Re: Bishop Tube Site

Technical Memorandum

Review of Bishop Tube Superfund Site and an Assessment of the Site's Proposed Residential Development

March 23, 2017

Figure 2: Snapshot of a portion of RIR Figure 6 showing TCE concentrations along Little Valley Creek.

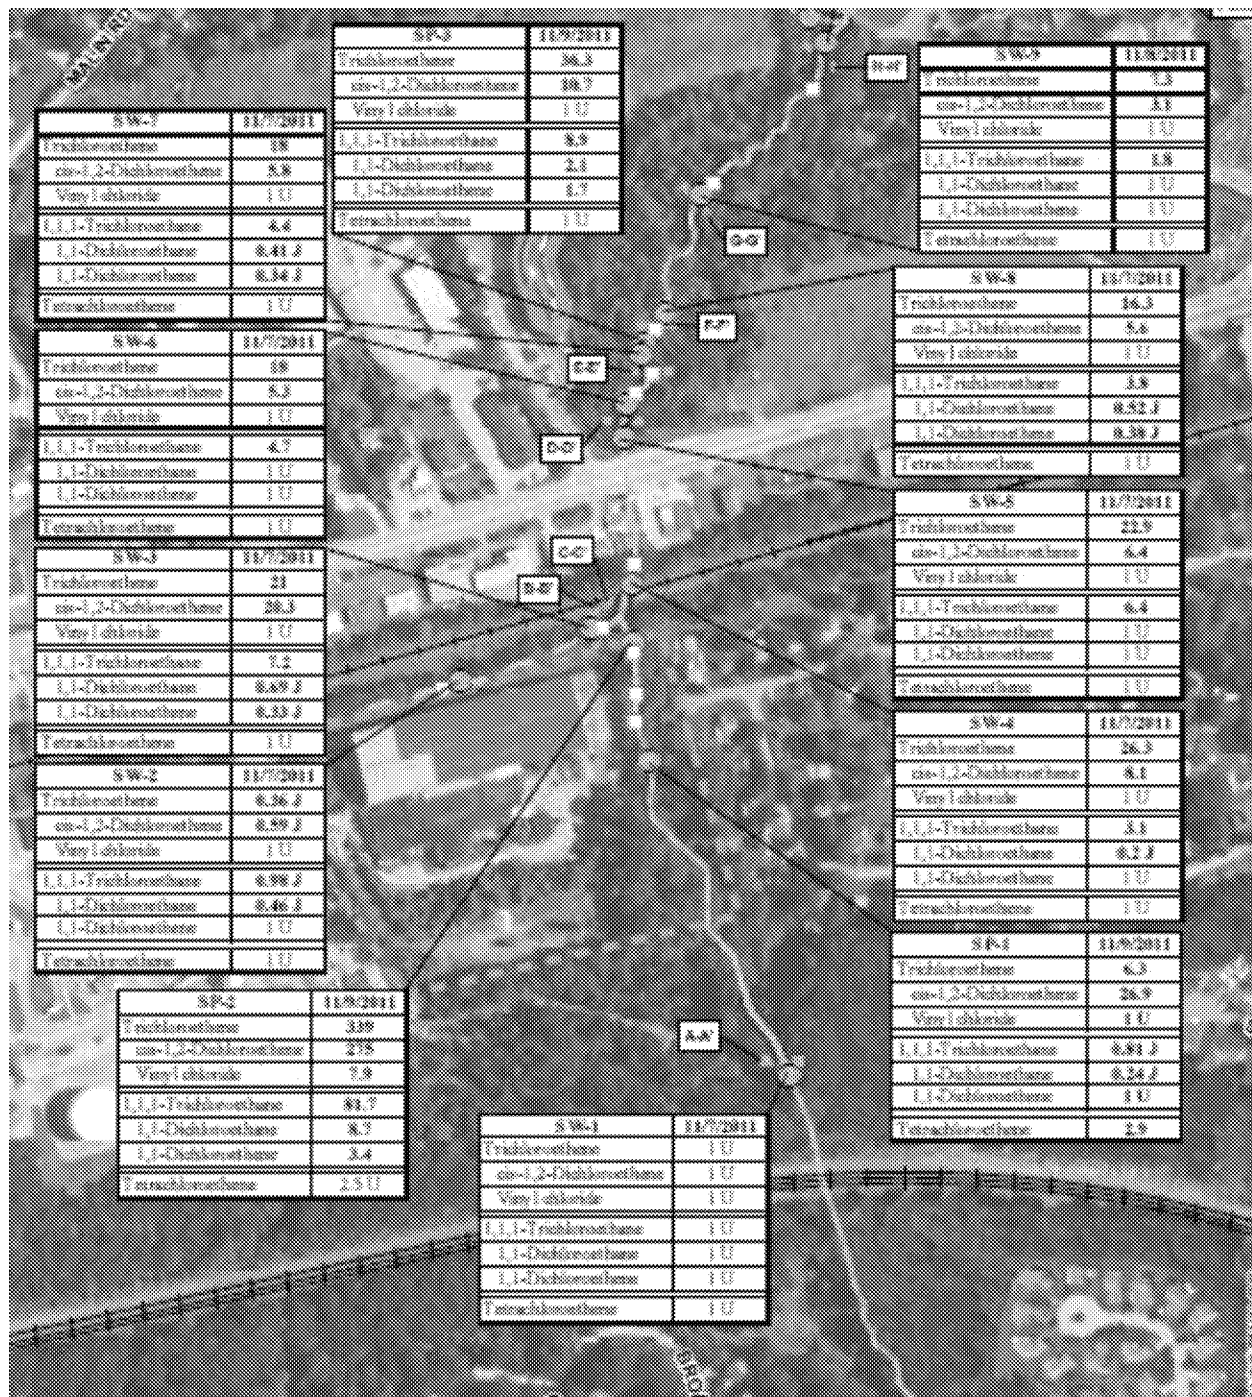
There are substantial amounts of TCE in groundwater throughout the Bishop Tube site (Figure 2). Groundwater flowing beneath the site discharges to springs and to the LVC just east of the site, both increasing the flow and the load of TCE discharging from the site (Figure 2). These streams transport TCE downstream to Valley Creek and the Schuylkill River.
